# NEW SINGLE FAMILY RESIDENCE

## LAI FAMILY

PLN2015-00011

**TO:** Planning Commission

Photos taken from rooftop 552 Farallone Ave. towards the North

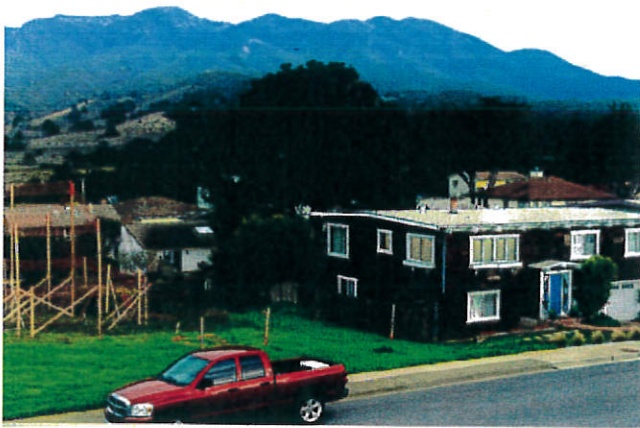
This house is 64% larger than the average home on a 5000 sf or less lot in sample area

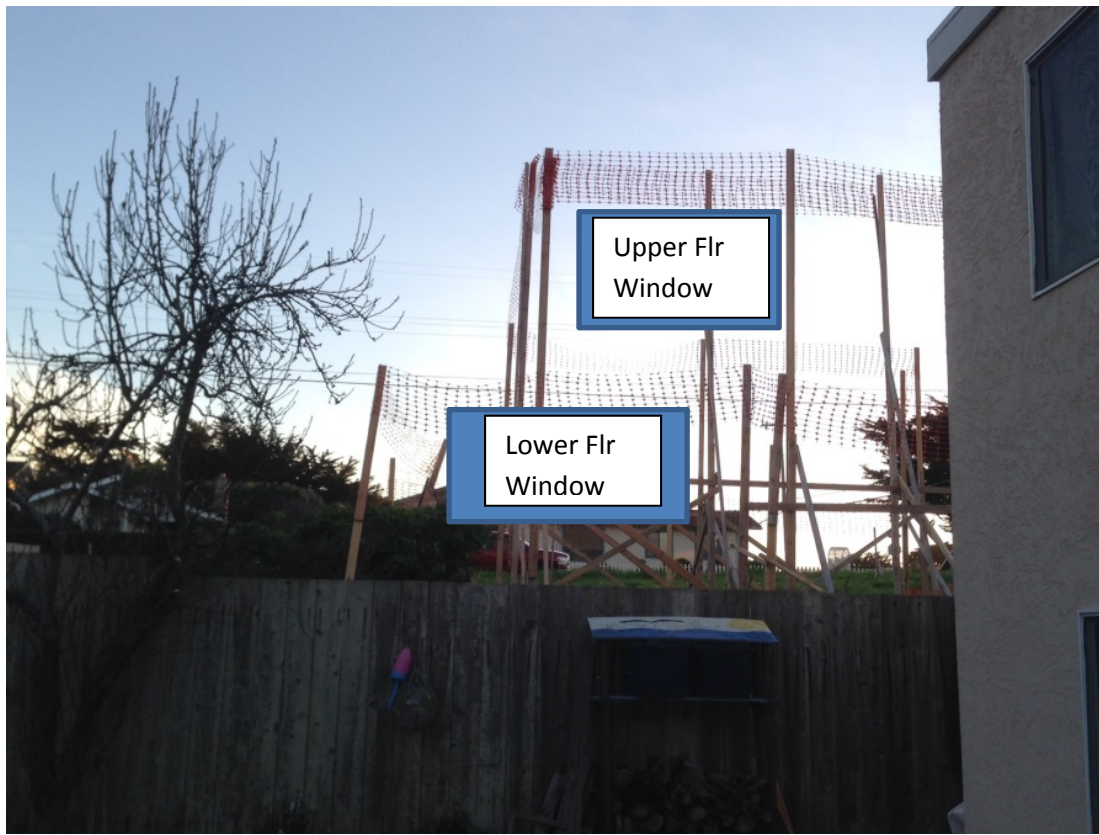
The below picture is taken from the center of the deck in my back yard. This deck is adjacent to my house and shows that the proposed oversized side windows are front and center to the view from my deck. From inside the proposed construction, anyone looking out either the first floor Master bedroom window or the second story window will be peering directly on to my deck and my entire back yard.
